Subject: Dam Inspection Report for LITTLE FALLS DAM,
Field File No. 55.01, Key Sequence No. 54, St. Croix County.

Dam Inspection Report

Little Falls Dam

Inspection Date: October 17, 2011

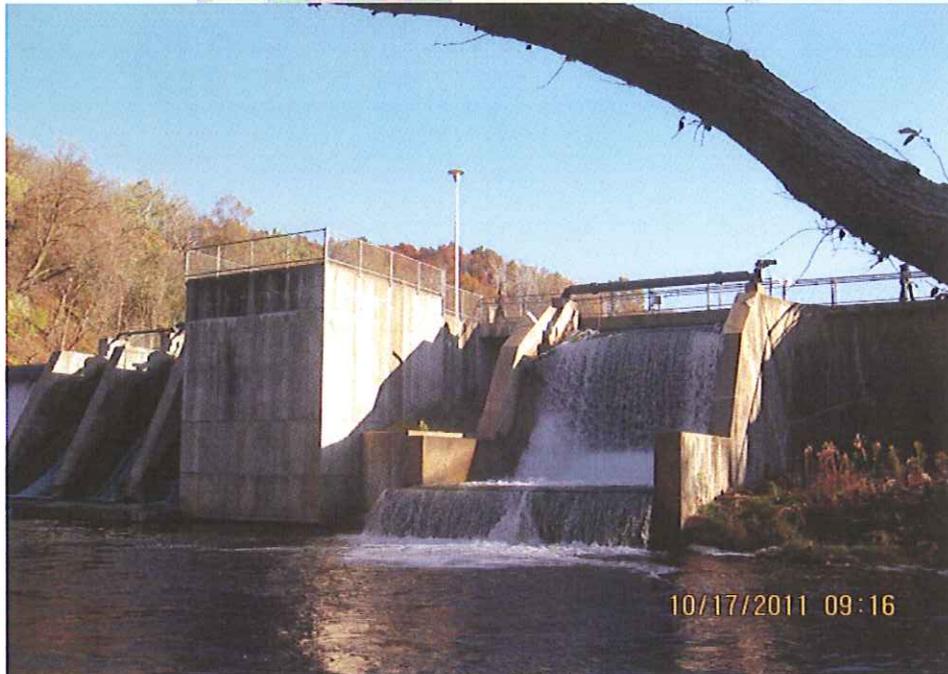
The spillway pictured above is the primary spillway

One large Tainter gate and three smaller Tainter gates are used as auxiliary spillways. The larger Tainter gate above has flow over topping the gate.

VI. Spillways

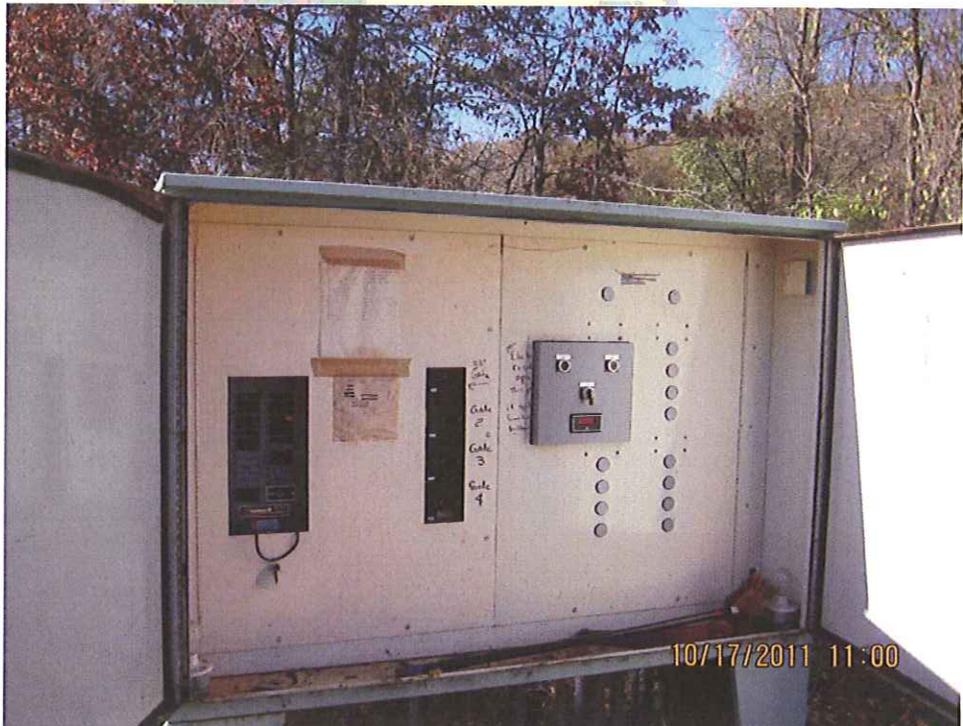
- A. Fix crest (See picture above.)

The fix crest spillway appears to have been reconstructed in recent years. The condition of the spillway appeared to be adequate but a thorough inspection could not be done because the impoundment was at full pool and the spillway was flowing.

- B. Tainter gates (See picture above.)

The four Tainter gates have been repaired or modified in recent times, in the last 20 years or so, and appeared to be free of corrosion. Flow was going over the top of the larger Tainter gate at the time of the inspection so the trunnion arms, trunnion pins and bearings, vertical ribs, and arm bracing could not be inspected..

10. The next inspection of the dam should include a draw down to expose the Tainter gate components, the face of the concrete dam, the concrete at pinions and surrounding the Tainter gates, and the concrete making up the spillway.

C. Concrete Condition

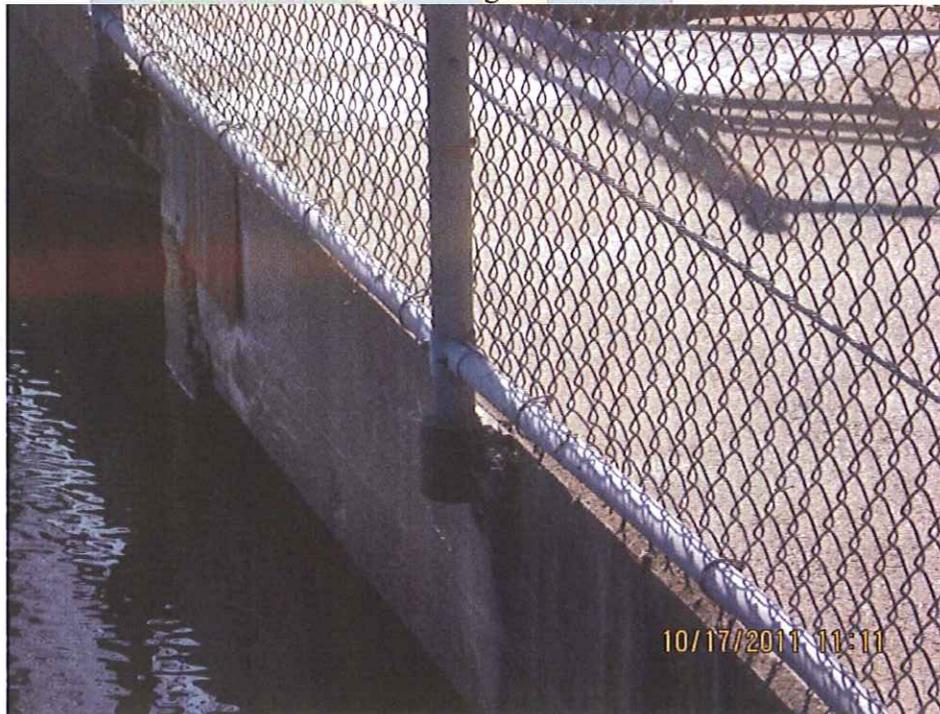
There are cracks from the cable winder down to the trunnion pin and beyond. This is next to the former power house area. Note that there is no way to access the trunnion pin and bearing for lubrication. The same situation exists for all four gates.

Concrete patching on the walkway, the lighter colored material, and shifting of the concrete at the crack near the water line.

The concrete around the pinions of the Tainter gates should also be inspected. There are cracks at the pinions and some heaving of concrete in the walkway across the abutment of the Tainter gate and former powerhouse.

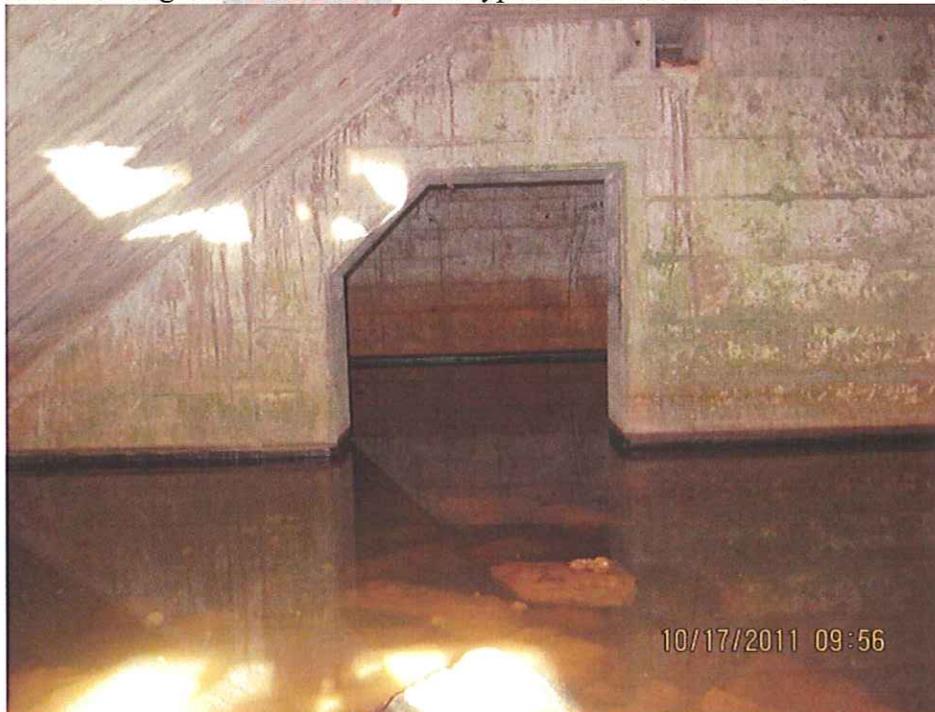
This is one of the concrete arches of the dam. The concrete has small cracks and cracks with leaks that are leaving effervescence. This is typical of all of the arches.

This is the concrete below the left Tainter gate looking north to the former power house wall. The concrete appeared sound with no noticeable cracks or leaking.
